March 31, 1982
AW-82-21

APPLICATION FOR WITHHOLDING PROPRIETARY
INFORMATION FROM PUBLIC DISCLOSURE

SUBJECT: Response to Questions on WCAP-9561, "Bart-A1: A Computer Code for the Best Estimate Analysis of Reflood Transients" (Proprietary)

HOT ROD CLAD TEMPERATURE DURING REFLOOD TYPICAL FOUR LOOP PLANT WITH 15X15 FUEL

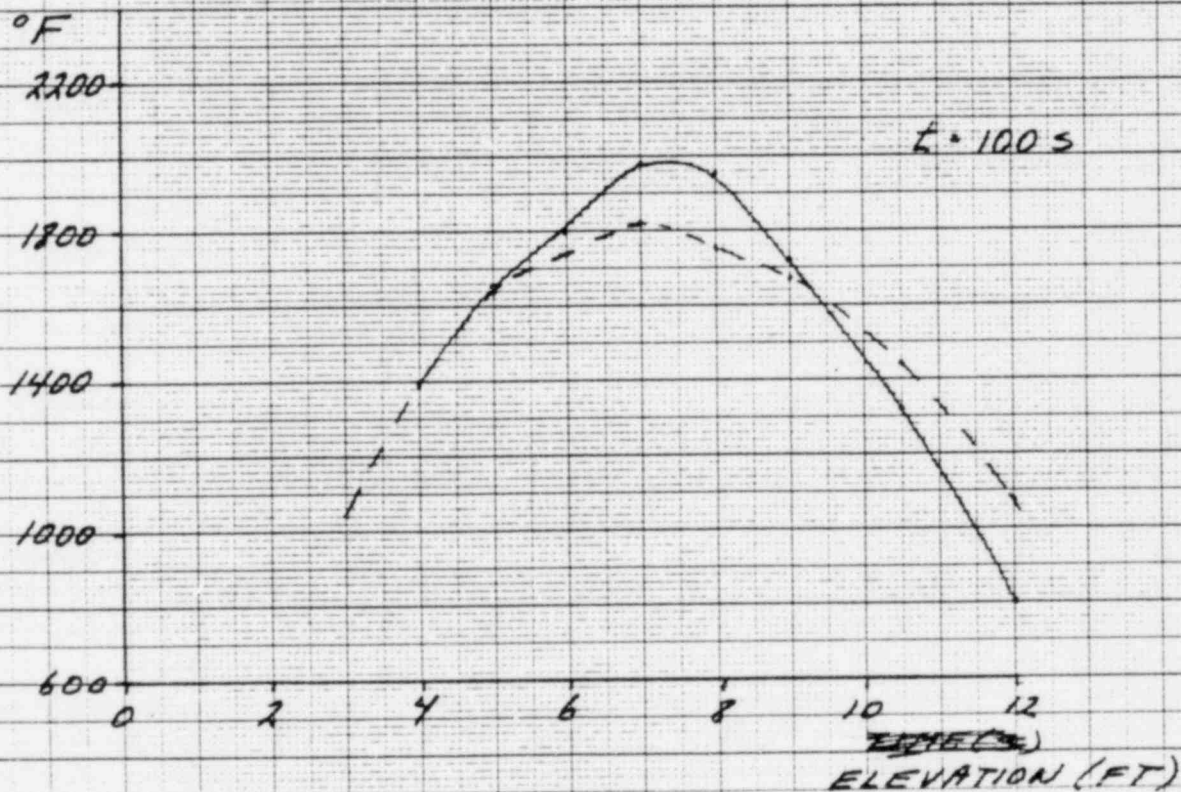
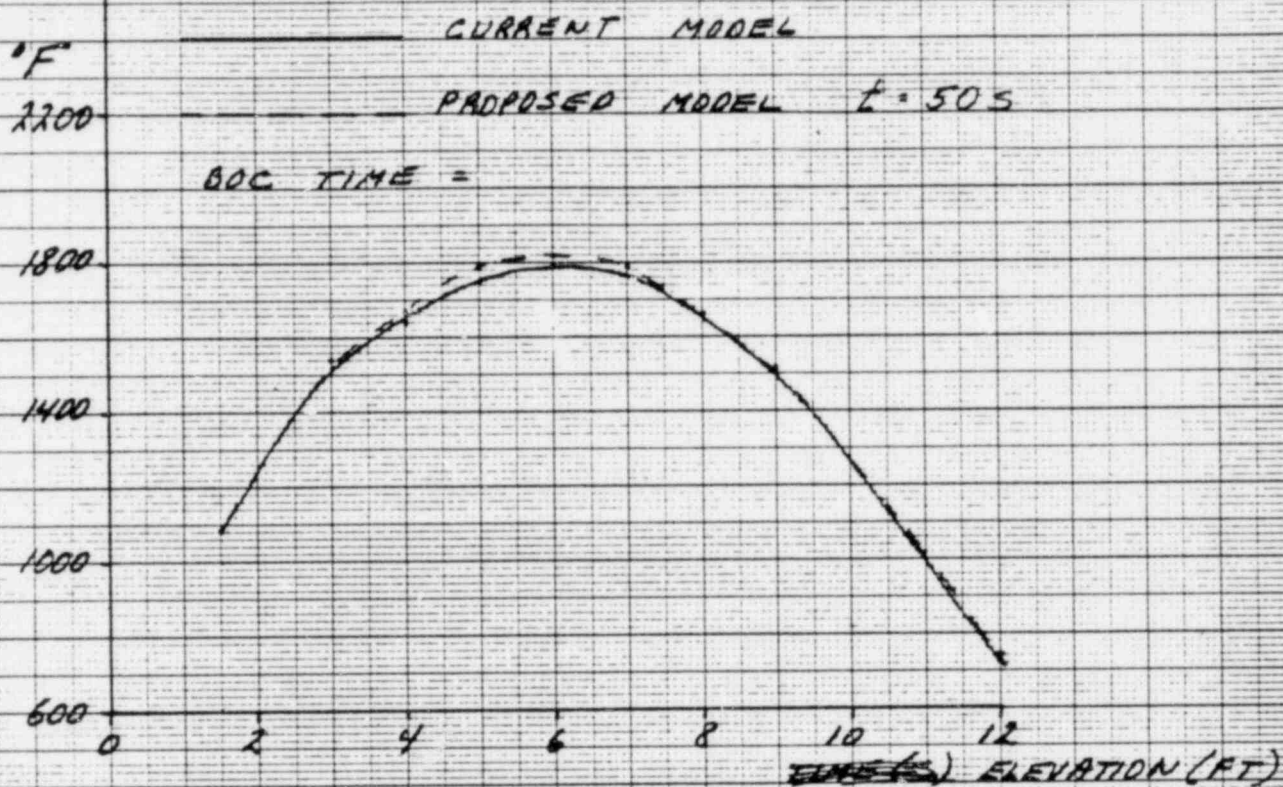
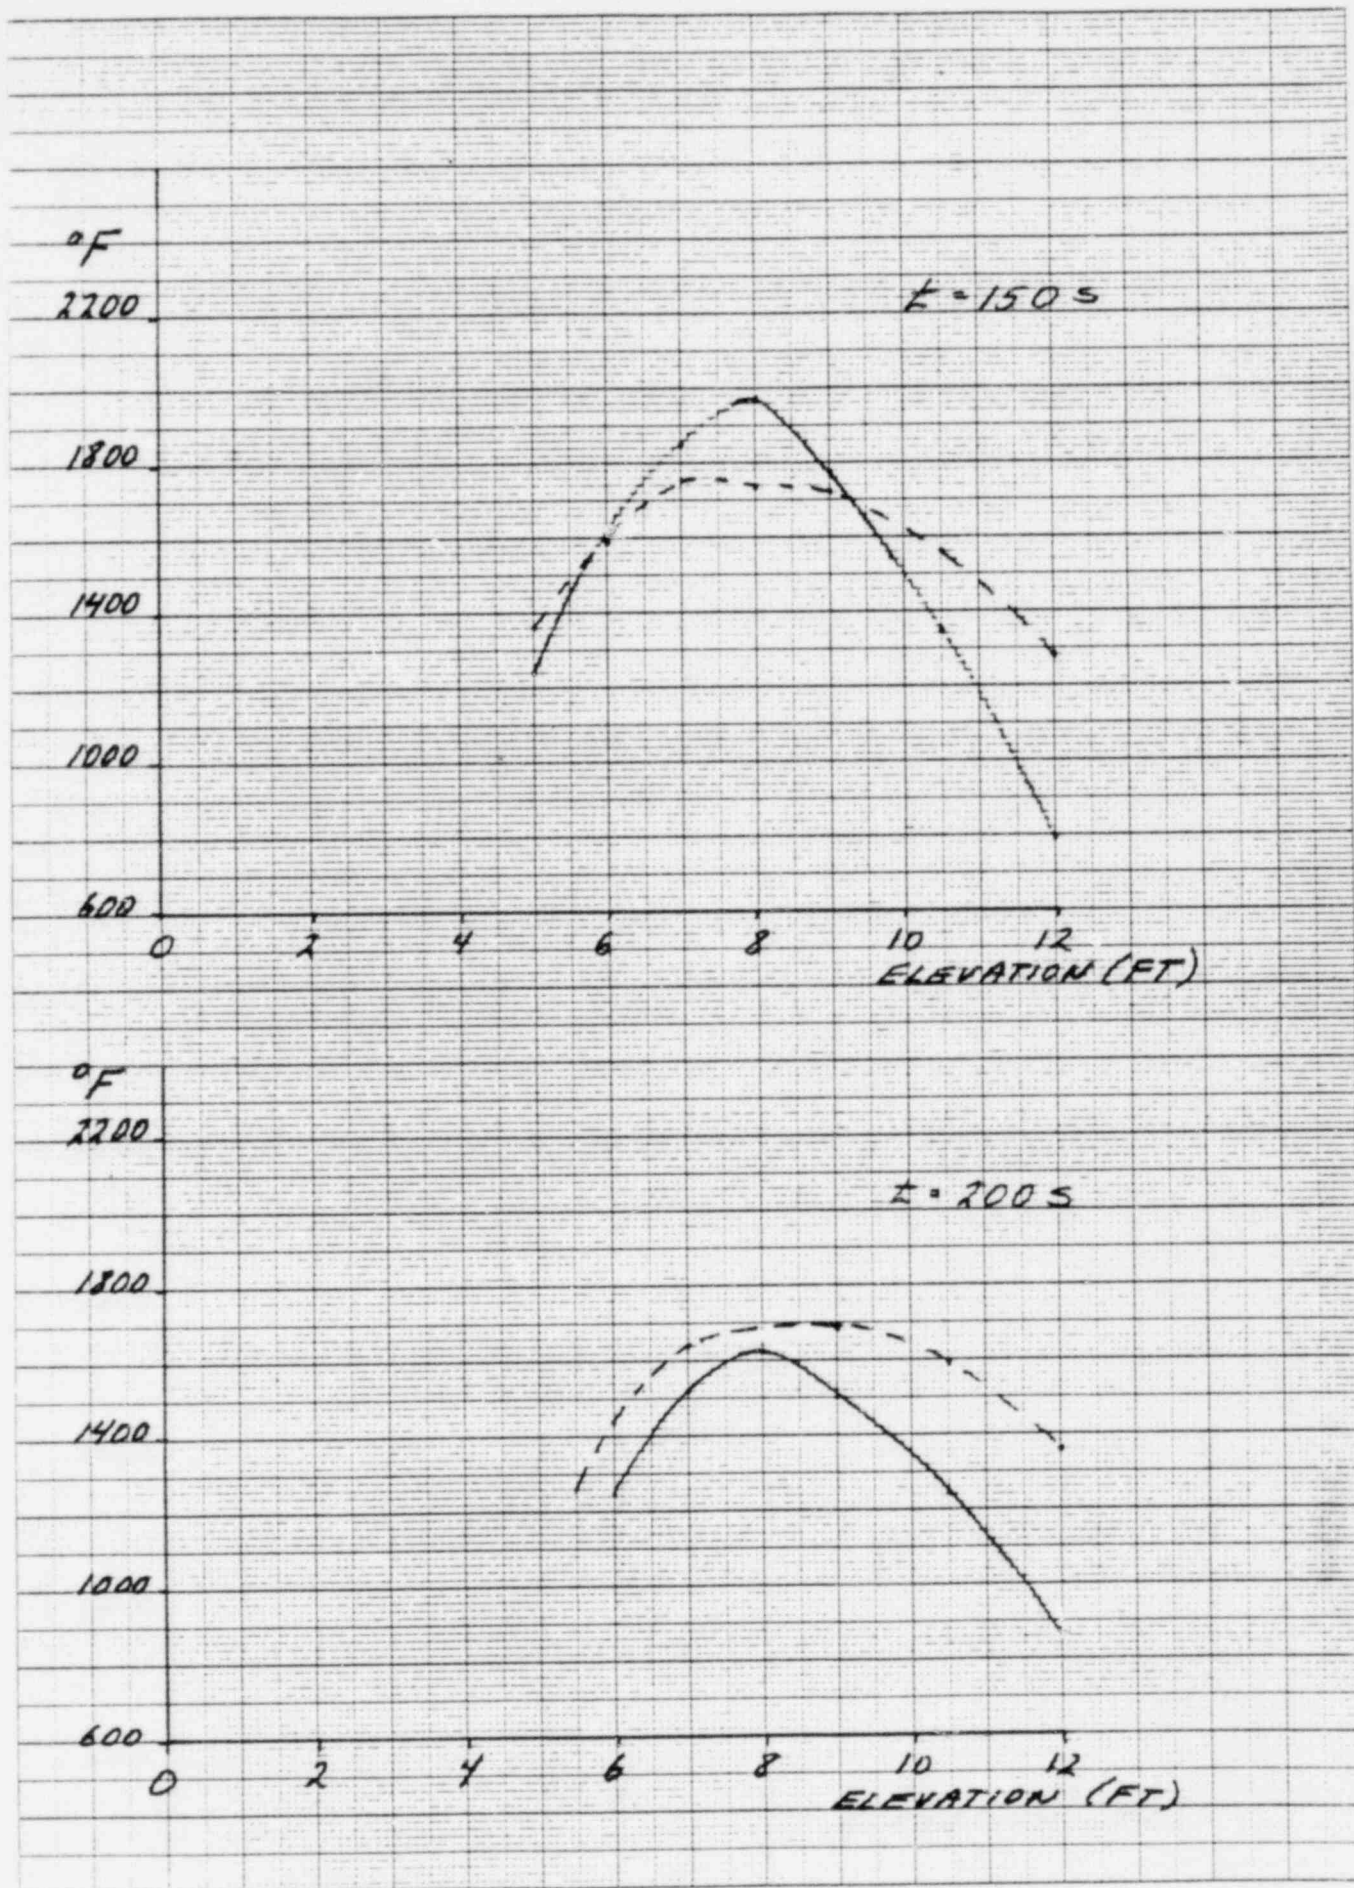
- 5.) Provide the comparisons of the peak clad temperatures using both the current ECCS evaluation model package and the proposed model.

Figures 1 to 4 show the hot rod axial temperature distribution from beginning of reflood to turn around for a typical four loop plant. The clad temperatures were calculated using the flooding rates shown in the response to question 2.

Figure 6-1 Flooding Rate Into Test Section Calculated for Run 3105B Expressed as Inches/Second

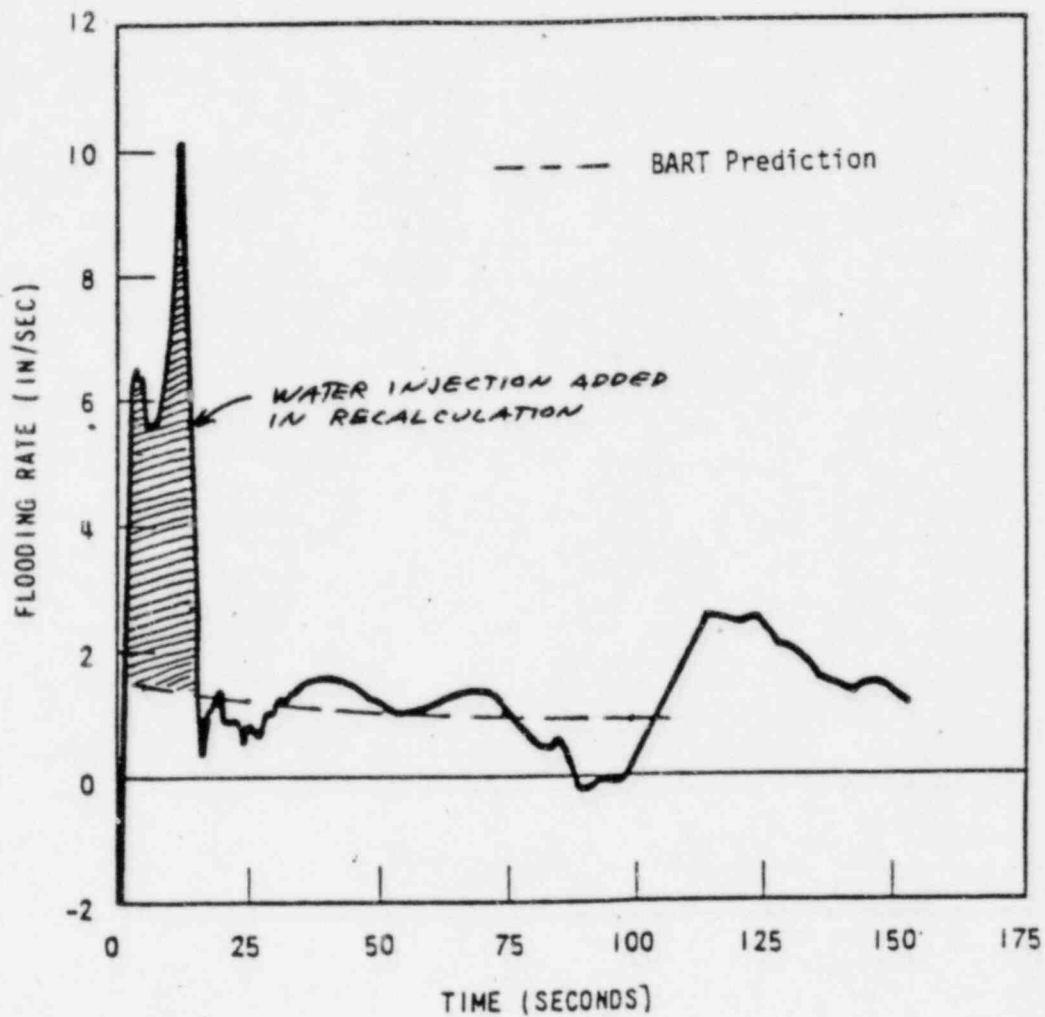
- 1) It was understood that BART required a flooding rate as input. Describe how the BART flooding rate prediction in Figures 6.1 and 6.4 was developed.

- 3.) How does one account for the substantial clad surface temperature over-prediction of Figure 6.2 and 6.5?

The major cause of the large clad surface temperature over-predictions of Figure 6.2 and 6.5 is the failure of the WREFLOOD-generated flooding rates to include the large initial injection rates that occurred in FLECHT-SET runs 3105B and 2714B. The discrepancies are apparent in Figure 6.1 and 6.4.

To demonstrate this effect, BART was re-run for FS3105B and 2714B. The single modification made to the respective inputs is an "augmented" flooding rate history which includes the high initial flooding rates. This modification is shown graphically on the accompanying versions of Figures 6.1 and 6.4

BART PREDICTION VS. AS 3105B
 6' ELEVATION

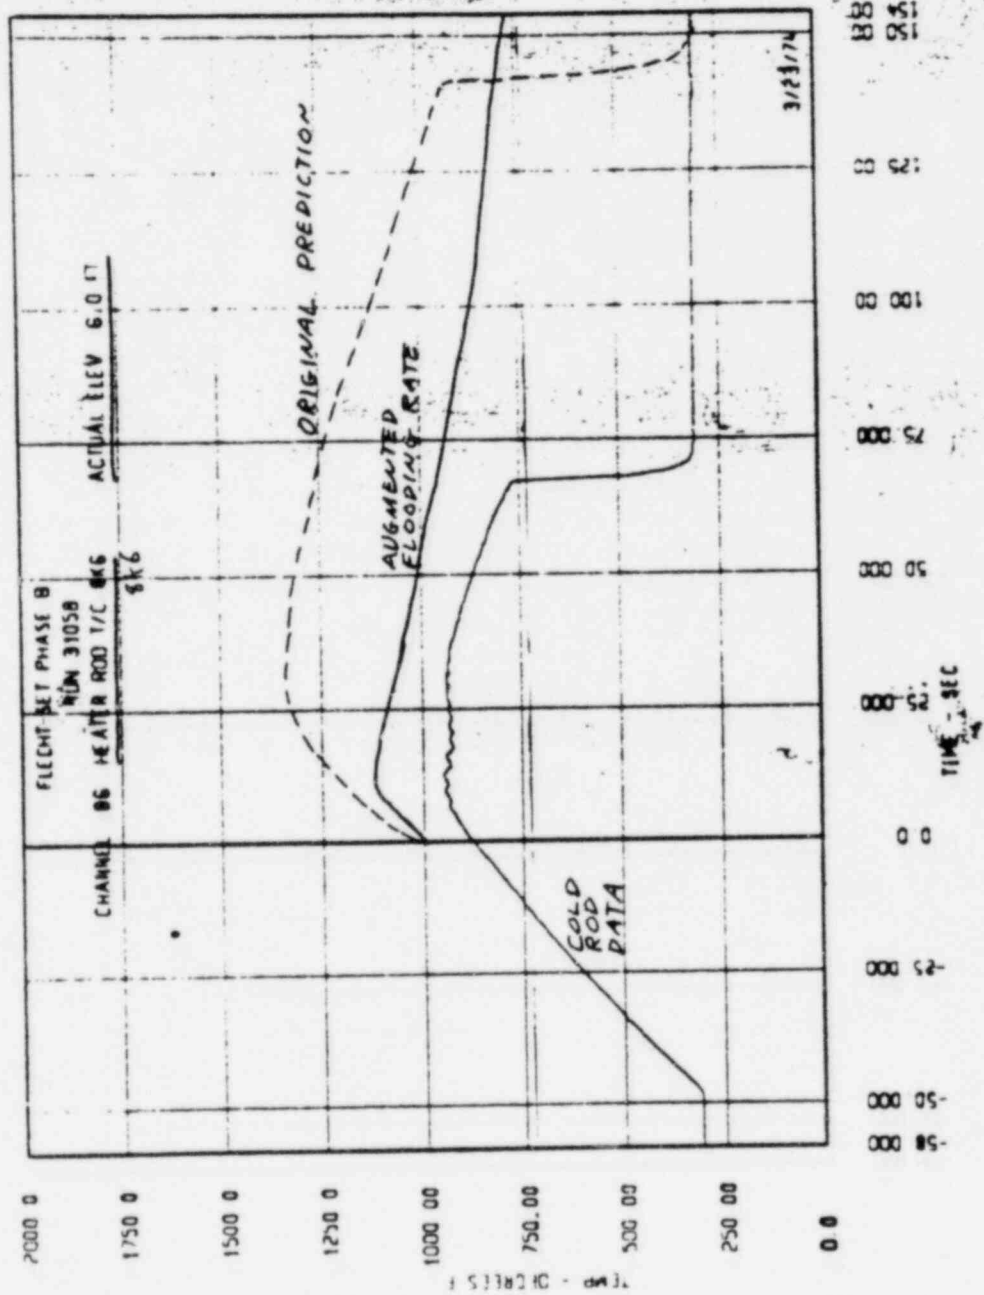
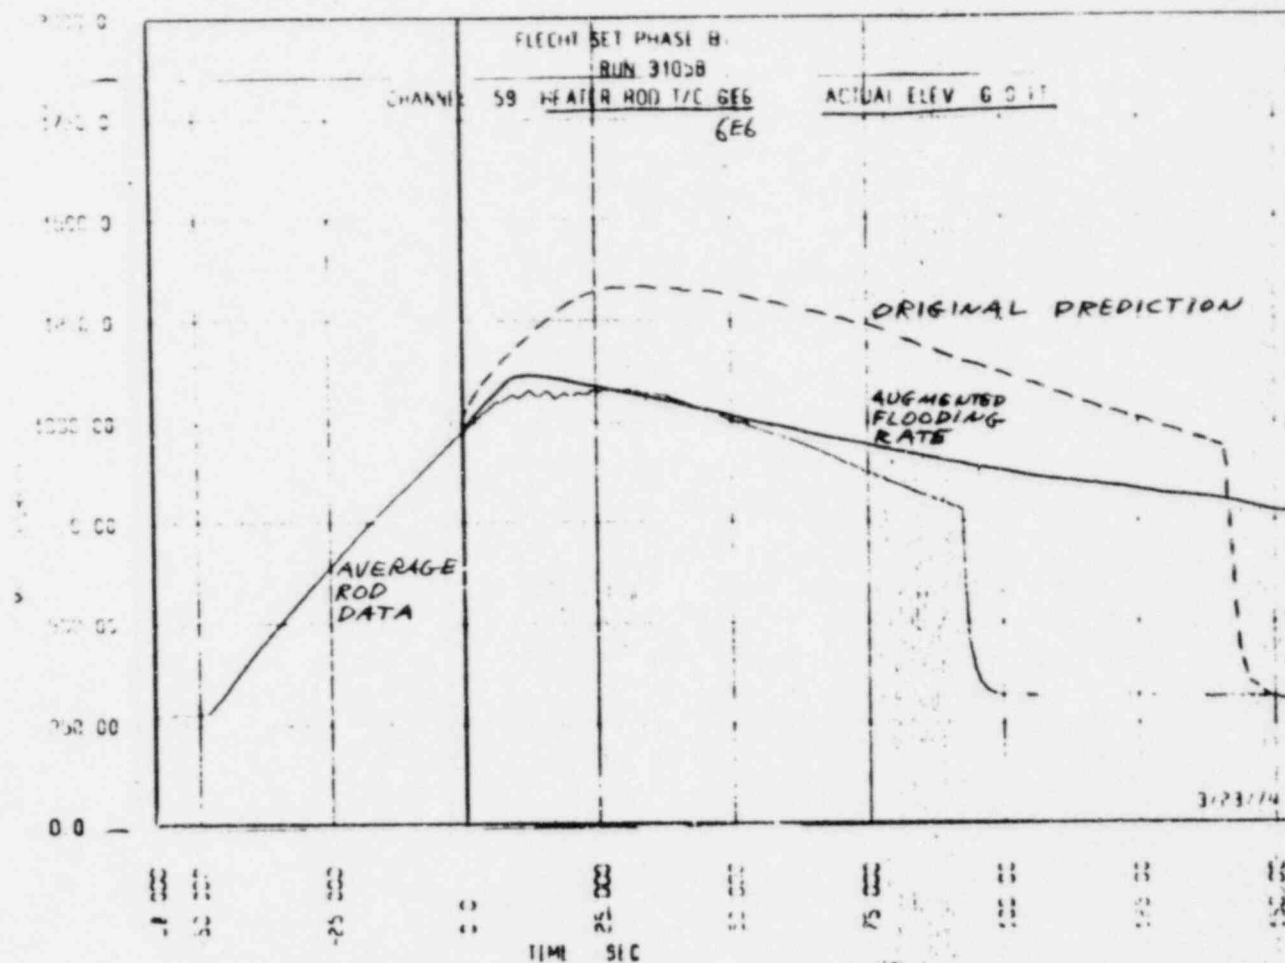
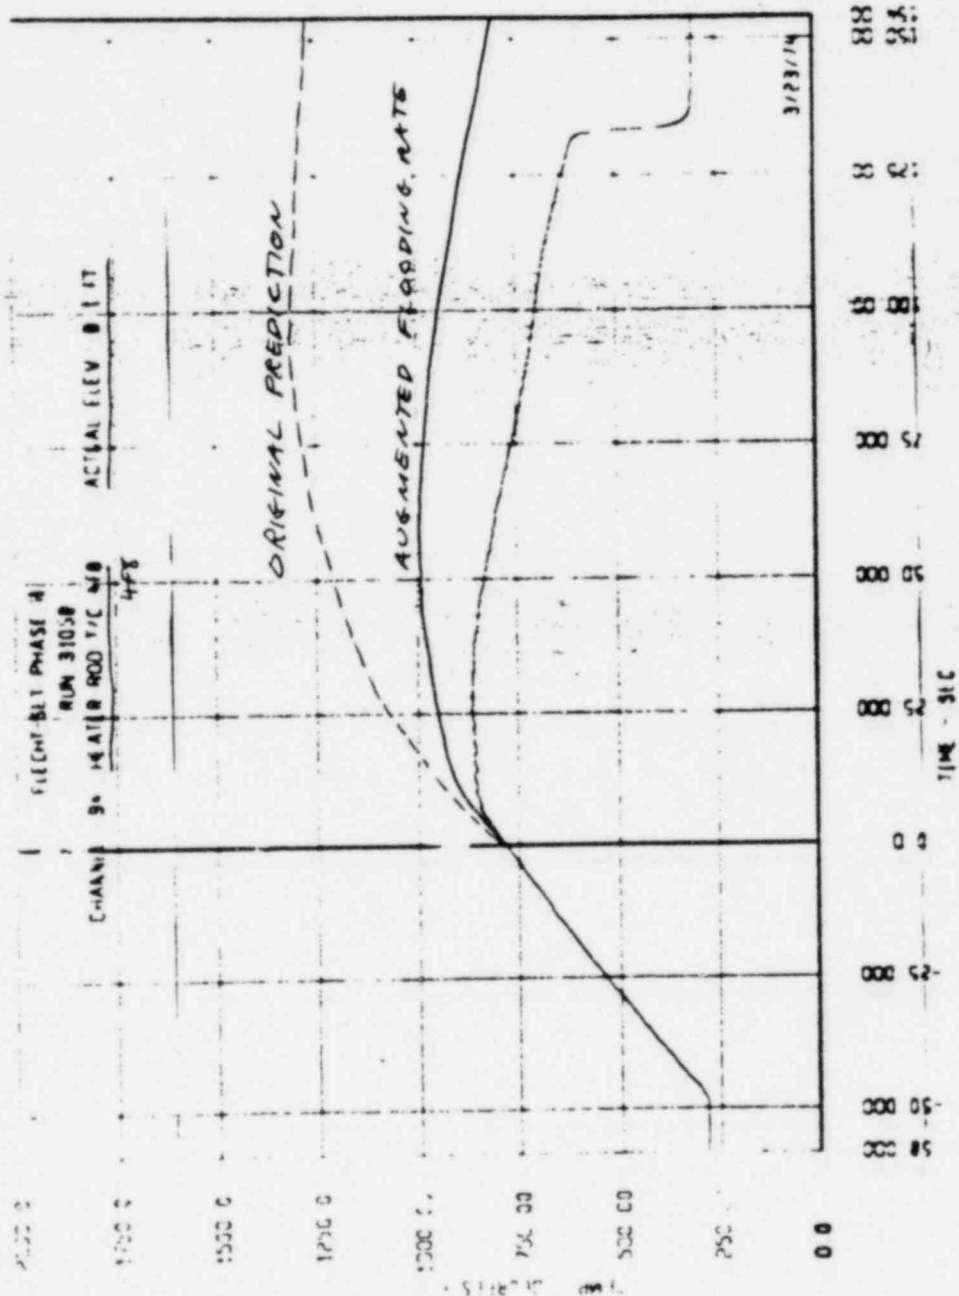
- 2.) The clad wall temperature comparison graphs in Figure 6.2 and 6.5 do not include elevations or rod identification. A more complete and detailed data presentation is needed.

The improvement in peak clad temperature predictions due to the modified flooding rate profiles is shown in the attached plots of clad temperature. These plots give the same basic information as the less explicit Figure 6.2 and 6.5 in the BART - A1 report.

At the six-foot elevation, graphs are presented for the hottest rod, the average rod (after which the BART calculated rod was modelled and to which the BART rod is most comparable) and the coolest rod. The selections were made from sixteen available thermocouple channels at the six-foot elevation.
